James Scarola
Vice President
Harris Nuclear Plant
Progress Energy Carolinas, Inc.

SHEARON HARRIS NUCLEAR POWER PLANT, UNIT NO. 1
DOCKET NO. 50-400/LICENSE NO. NPF-63
REQUEST FOR LICENSE AMENDMENT
TO CREDIT SOLUBLE BORON FOR FUEL STORAGE POOLS

SHEARON HARRIS NUCLEAR POWER PLANT, UNIT NO. 1
DOCKET NO. 50-400/LICENSE NO. NPF-63
REQUEST FOR LICENSE AMENDMENT
DESCRIPTION, BACKGROUND, AND TECHNICAL ANALYSIS

SHEARON HARRIS NUCLEAR POWER PLANT, UNIT NO. 1
DOCKET NO. 50-400/LICENSE NO. NPF-63
REQUEST FOR LICENSE AMENDMENT
PROPOSED TECHNICAL SPECIFICATIONS (TS) CHANGES

Figure 5.6-2
Pools "A" and "B" BURNUP VERSUS ENRICHMENT FOR PWR FUEL

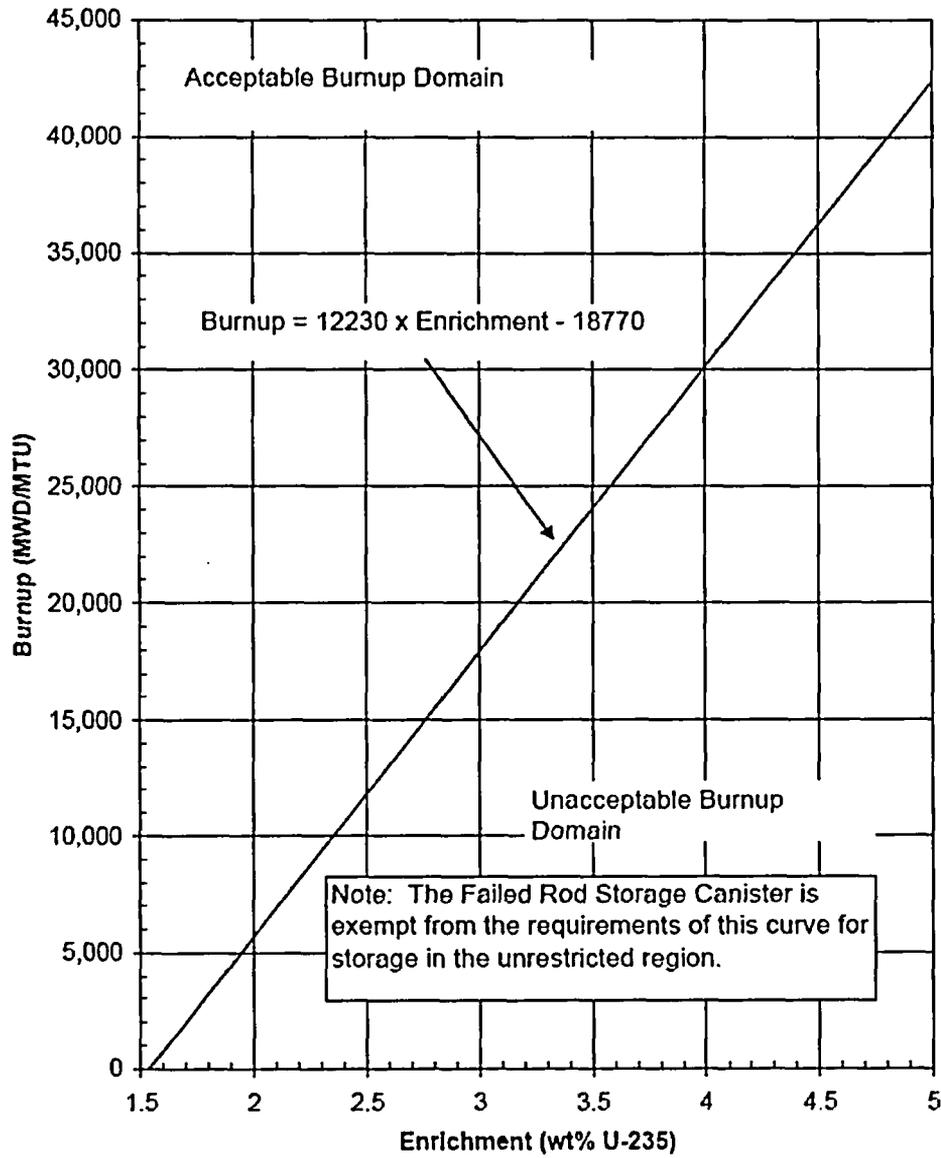
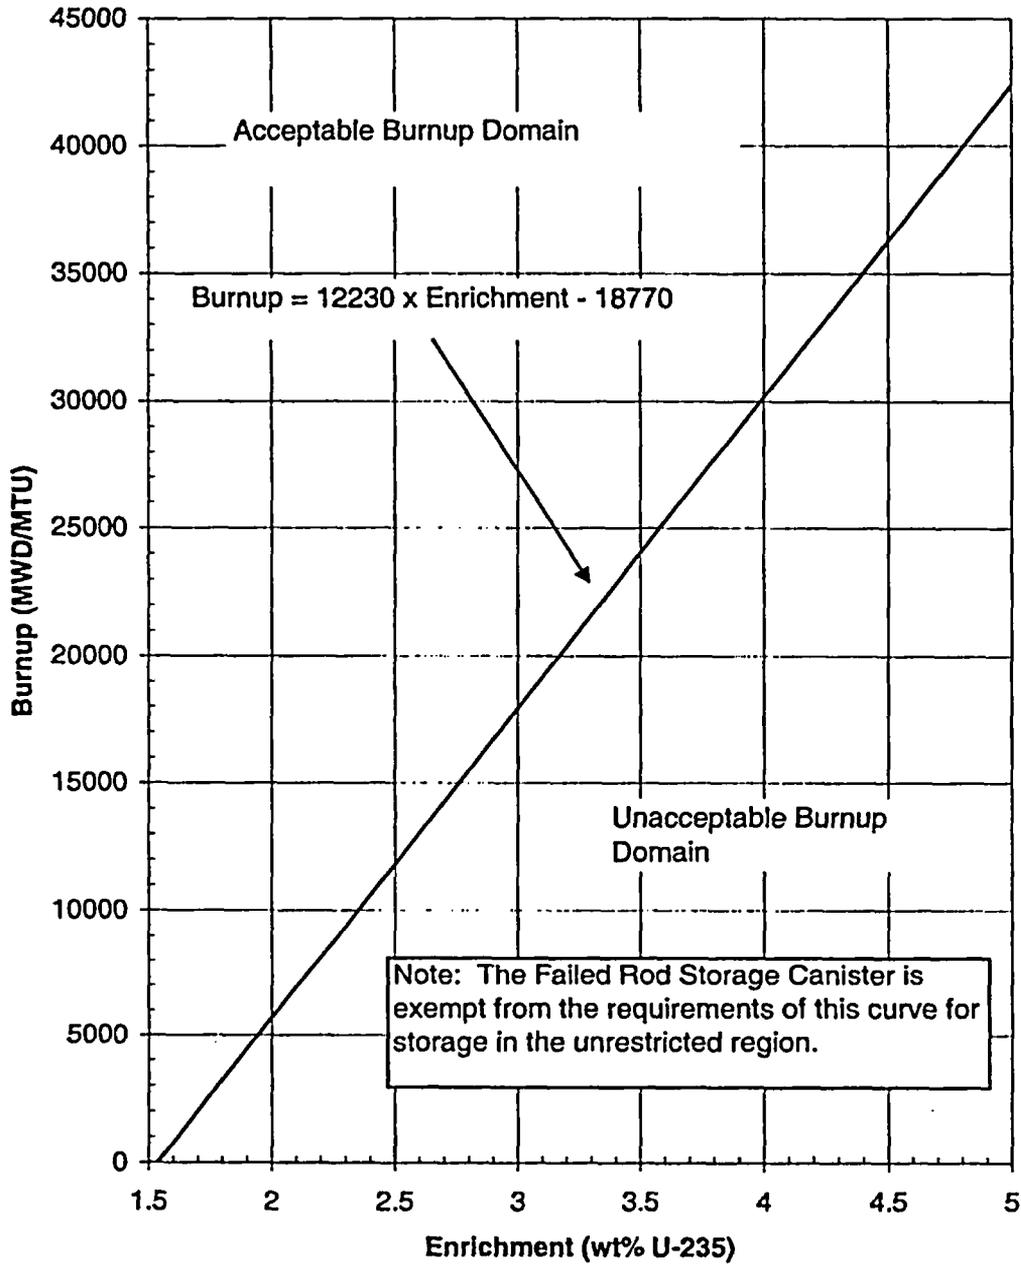
- A revision to Figure 5.6-1 is made to add the equation for the burnup curve and revise the title so that the existing figure is consistent with the proposed content of new Figure 5.6-2. The curve in Figure 5.6-1 is not changed.
 - A new Figure 5.6-2 is added to define the PWR fuel that meets the unrestricted storage in the Boraflex racks in Pools "A" and "B."
 - The specifications for the dry storage of new fuel are being added to TS Section 5.6.1.
3. A new TS Bases section has been added for the new TS 3/4.7.14 to provide information related to the criticality analyses and the various analysis assumptions, such as credit being taken for soluble boron for the Boraflex racks. An information copy of the proposed Bases change is also included with this submittal.

- c. A nominal 10.5 inch center-to-center distance between fuel assemblies.
 - d. Assemblies must be within the "acceptable range" of the burnup restrictions shown in Figure 5.6-2 prior to storage in unrestricted storage.

- d. Assemblies must be within the "acceptable range" of the burnup restrictions shown in Figure 5.6-2 prior to storage in unrestricted storage.
- e. Assemblies that do not meet the requirements of 5.6.1.1.d shall be stored in a 2-of-4 checkerboard within and across rack module boundaries. Less dense storage patterns (e.g. 1-of-4 or 1-of-5) are acceptable in place of 2-of-4.
